# OPTIONAL SERVICE BULLETIN

## OSB 42-128

## OSB 42NG-068

Retrofit Installation of Tablet Mount on the Canopy Frame.

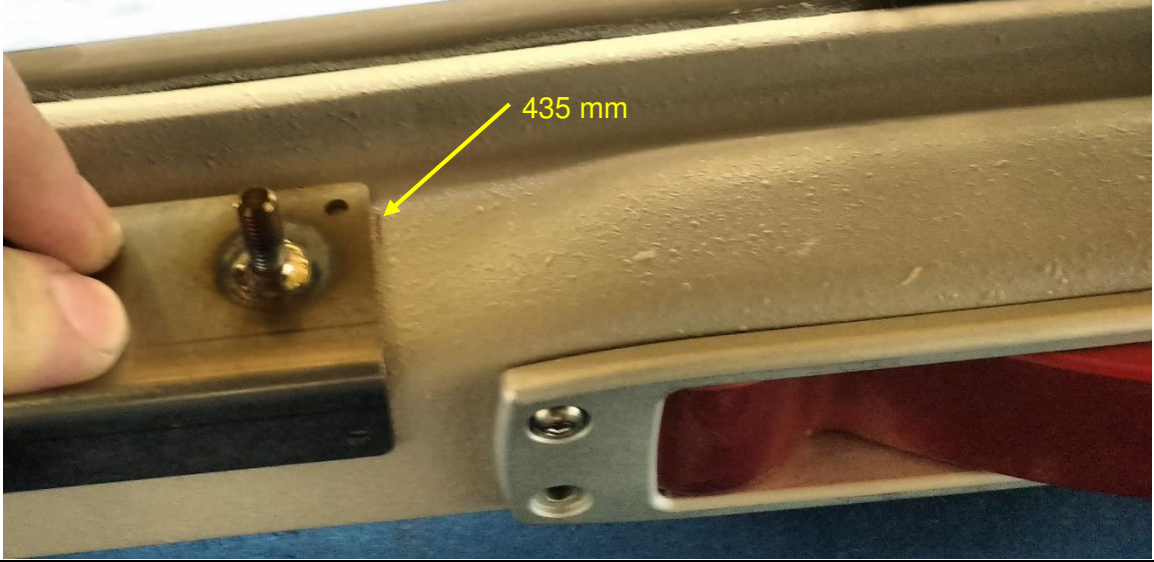
1	Remove the pilot and copilot arm rest from the canopy frame.
2	Pre fit the new LH and RH arm rest on the canopy frame and mark the rear end position with a pencil i.a.w. picture below. 
3	Remove the arm rest and measure 435 mm forward, mark the position.

4	<p>Use the fastening plate as a template and drill the 4 holes.</p> 
5	Rivet the fastening plate on to the canopy frame.
6	Transfer the hole position from the fastening plate bolt to the arm rest.
7	Prepare the surface of Arm Rest and canopy for bonding.
8	Bond the arm rest on the canopy frame with MS 939. Fix the arm rest with bar clamps on the canopy frame.
9	<p>Mount the tablet base.</p> 
10	Install the placards D44-1133-20-23 LH and RH and D60-1133-10-05_ 1 LH only.
11	Clean working areas, check for foreign objects.
12	Check all altered, replaced, repaired parts for proper function.
13	Test all systems in working area for function.
14	Make all necessary entries in the airplane logs.
